Subject: SAS-2: Making 07-193 into an Annex

This is the re-creation of 07-193r1 putting it into a form that can be placed into the SAS-2 standard as an informative annex.

Figure 1 — Reference transmitter test load physical characterization

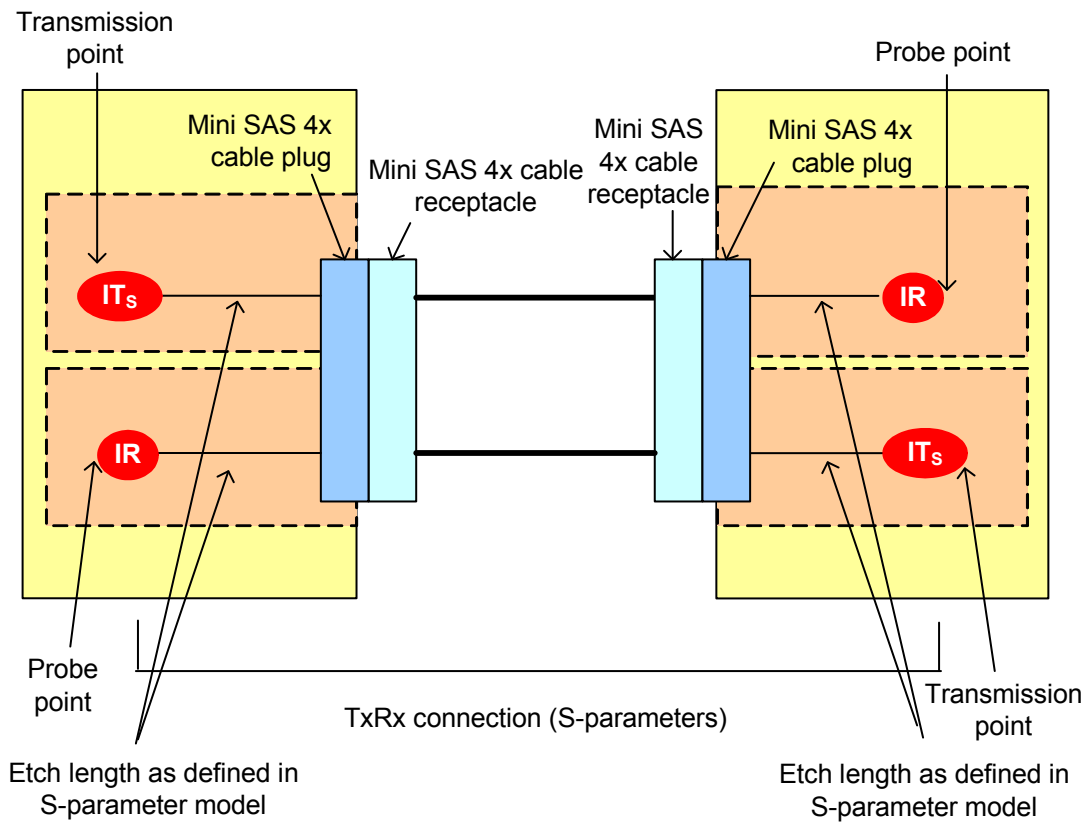
Figure 1 shows the physical model used to measure the reference transmitter test load. The etches between the transmission points and probe points may be included in an S-parameter measurement of a TxRx connection. Although these etches add extra loss to the TxRx connection, they are considered to be an

acceptable amount of loss for simulation purposes when restricted to a configuration similar to the reference transmitter test load.

Figure A.1 — S-parameter model of the reference transmitter test load

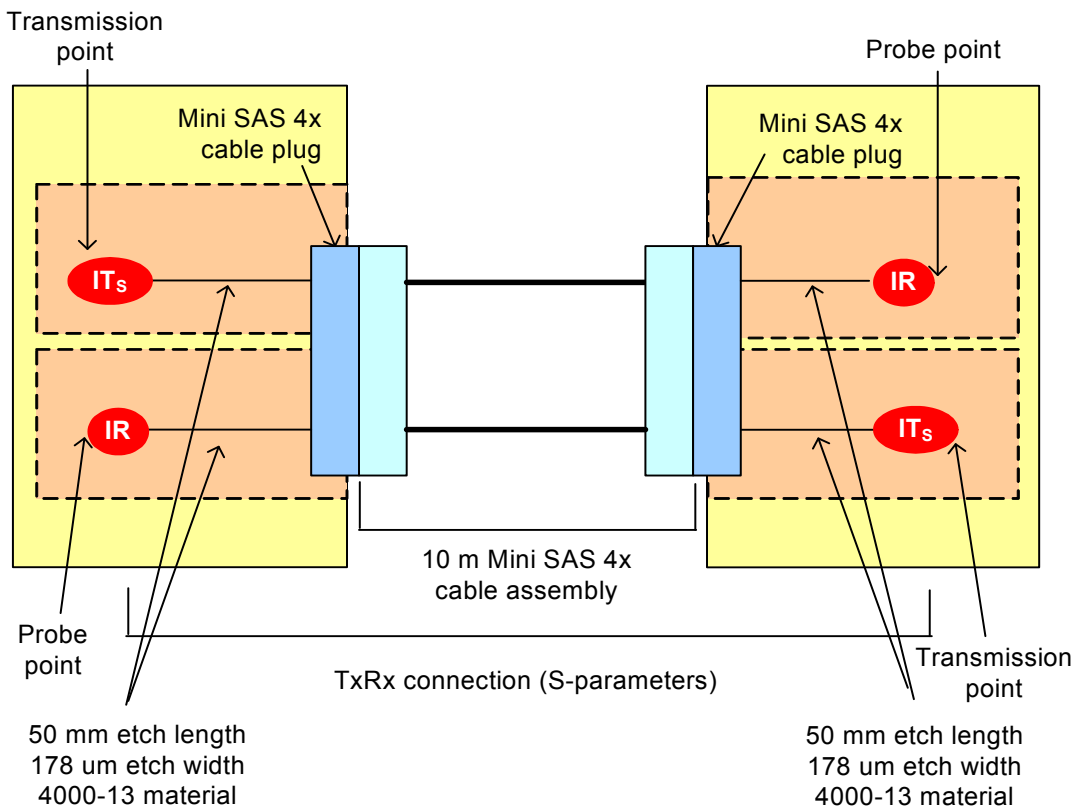
The S-parameter model of the reference transmitter test load consists of:

- a) an etch length of 50 mm with an etch width of 178 μm between the IT_s (see 5.3.6.5.4) and the Mini SAS 4x cable plug (see figure A.1) in 4000-13 material environment;
- b) 10 m Mini SAS 4x cable assembly; and
- c) an etch length of 50 mm with an etch width of 178 μm between the IR (see 5.3.7.4.3) and the Mini SAS 4x cable plug (see figure A.1) in 4000-13 material environment.

Figure A.2 — S-parameter model of the reference transmitter test load setup

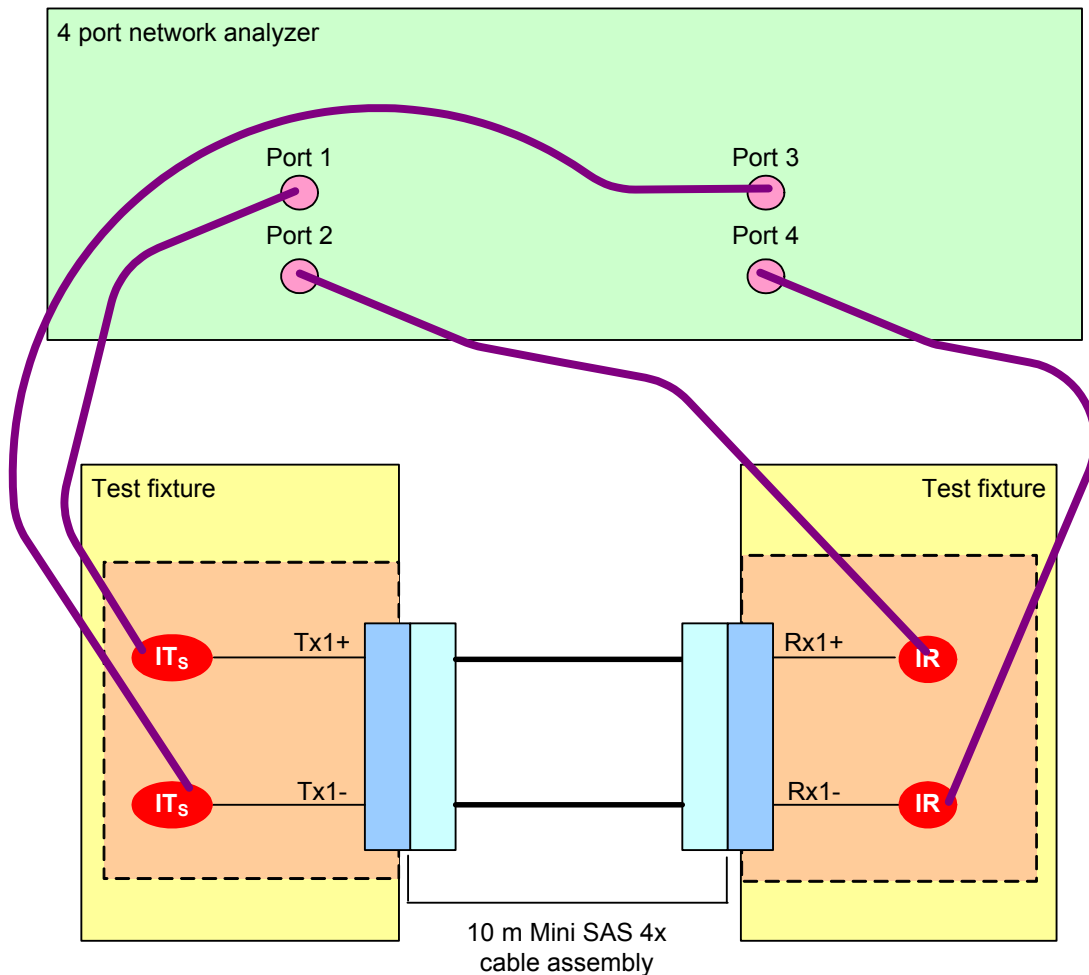
The following lists equipment that may be used to replicate the S-parameter model shown in figure A.1:

- a) Agilent E8364B PNA series network analyzer;
- b) Agilent N4421B s-parameter test set;
- c) Agilent Physical Layer Test System (PLTS) version 3.01;
- d) Molex 26-circuit External iPass™ Test Fixture (PCB 73931-2540); and
- e) 10 m Mini SAS 4x cable assembly.

The equipment is interconnected as shown in figure A.2.

Figure A.3 — Reference transmitter test load waveform

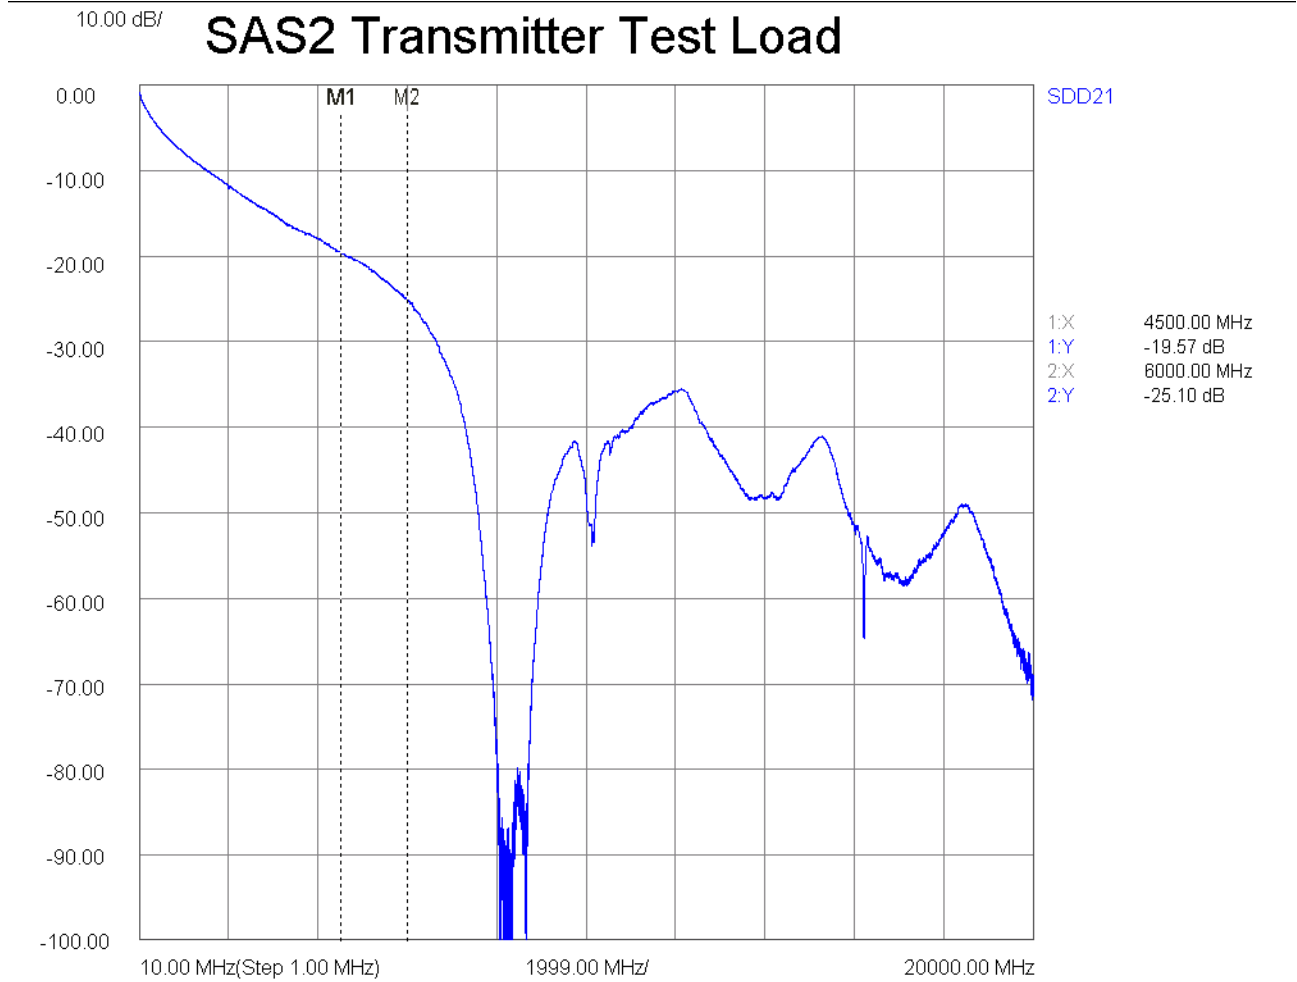
To generate the S-parameters for the reference transmitter test load sweep the 4 port network analyzer from 10 MHz to 20 GHz in 1 MHz steps. The resulting differential insertion loss waveform should be similar to that shown in figure A.3.
